CINTICHEM, INC.
P.O. BOX 816
TUXEDO, NEW YORK 10987 (914) 351-2131

March 8, 1991

REF: (1) Cintichem Letter JJM/17.91B dated January 21, 1991
(2) NRC Meeting Minutes, Docket 50-54 and 70-687 dated
March 4, 1991

The above referenced correspondence pertains to a Cintichem proposal to modify the decommissioning project whereby certain tasks may be started while reactor fuel remains on site. It was resolved in a recent meeting between NRC and Cintichem, that is documented in Reference (2), that certain modifications to the Decommissioning Plan would be required. Those modifications as listed below are hereby submitted for review and approval. The Plan sub section numbers are cross-referenced to the task item numbers that were originally proposed in Reference (1).

FIGURE 4

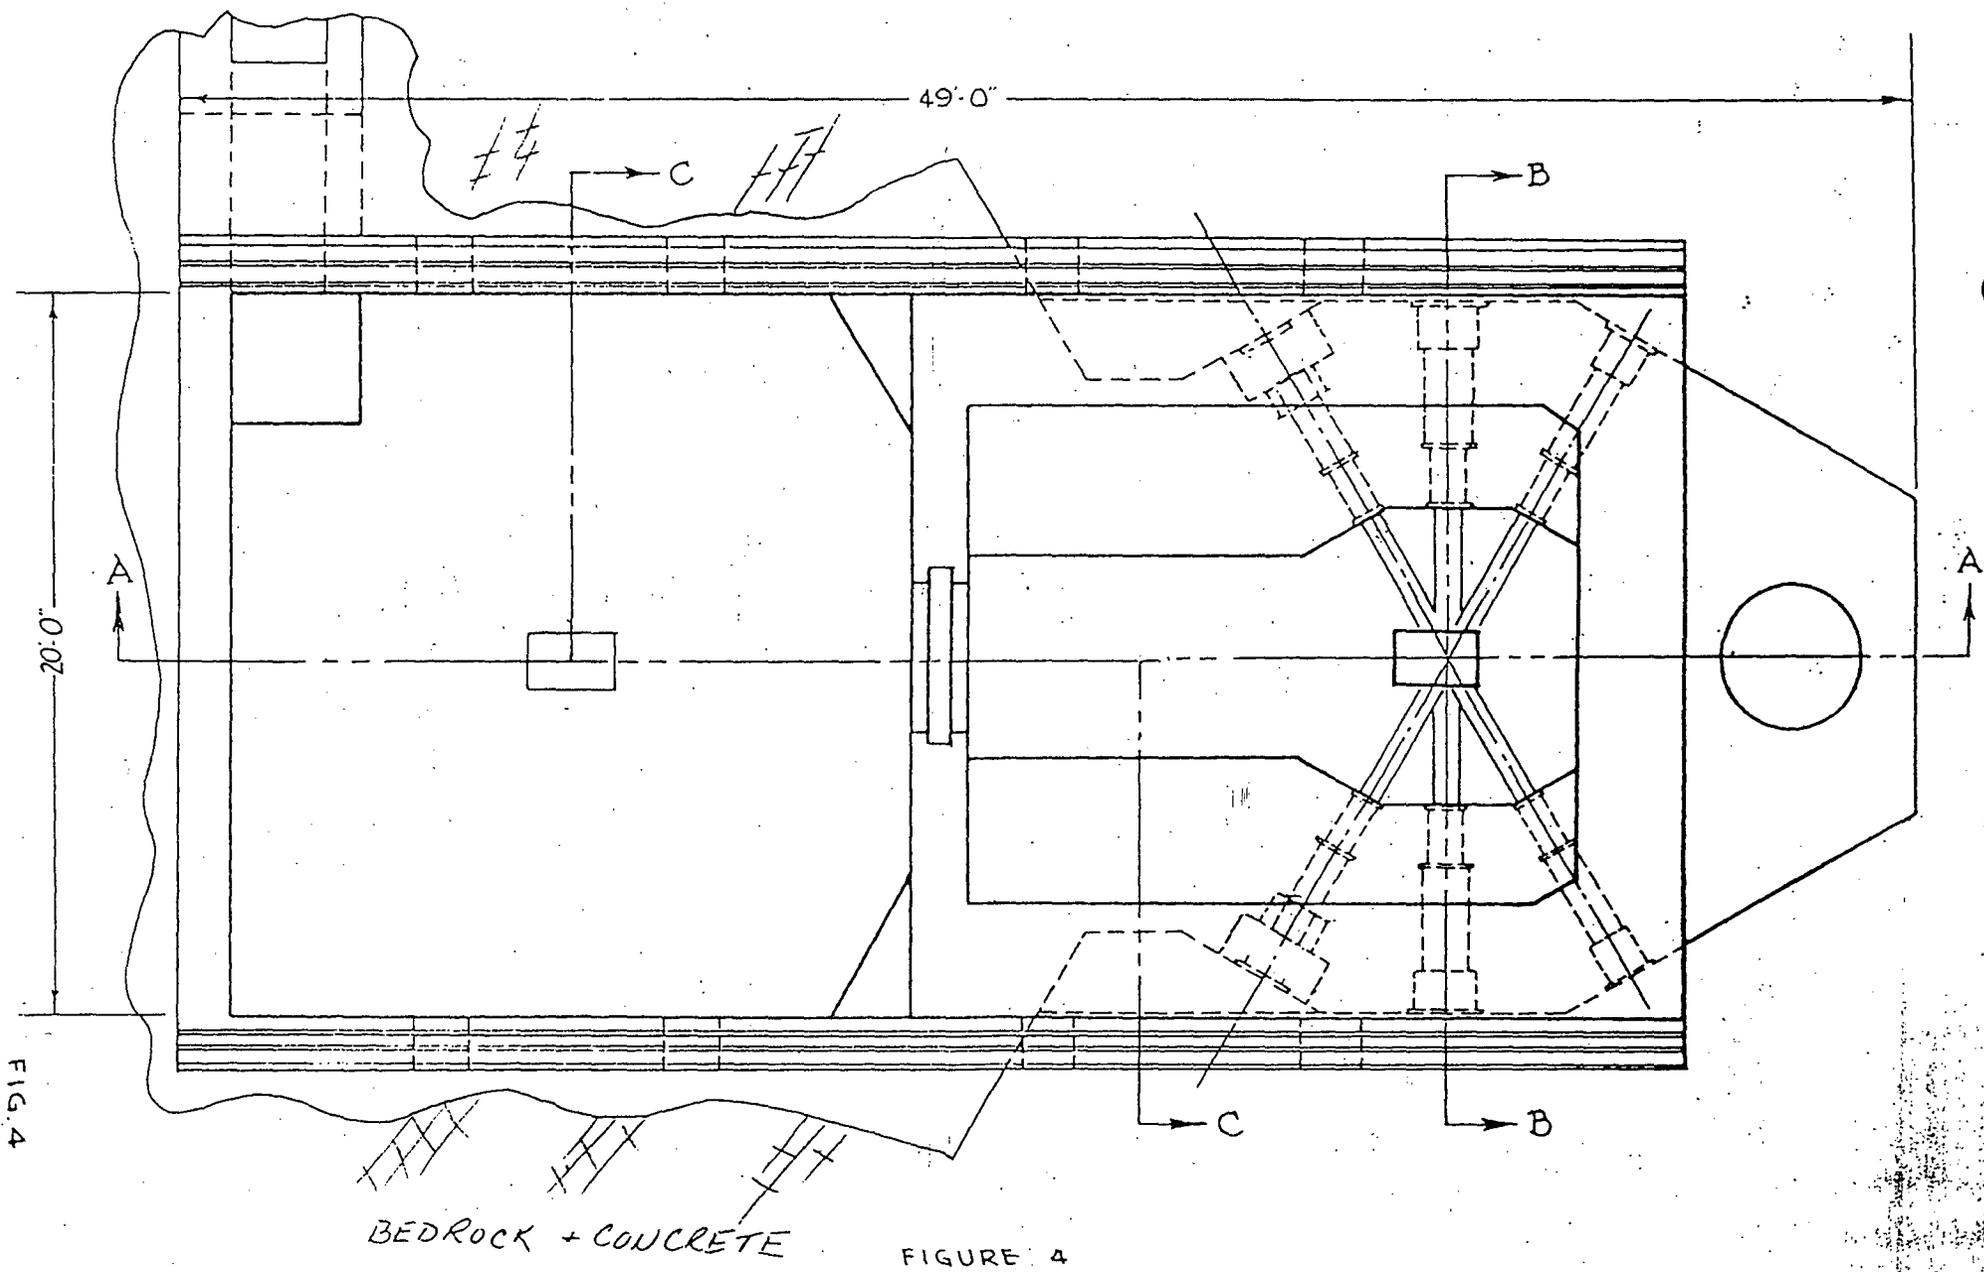
There are no other pathways for inadvertent drainage of the pool. Figures 4 and 5 are a plan view and elevation respectively of the reactor pool and stall at the upper level. The pool is built into bedrock except for the east side. This side is comprised of the berm and the dam. Except for the core coolant outlet and return pipes there are no penetrations.
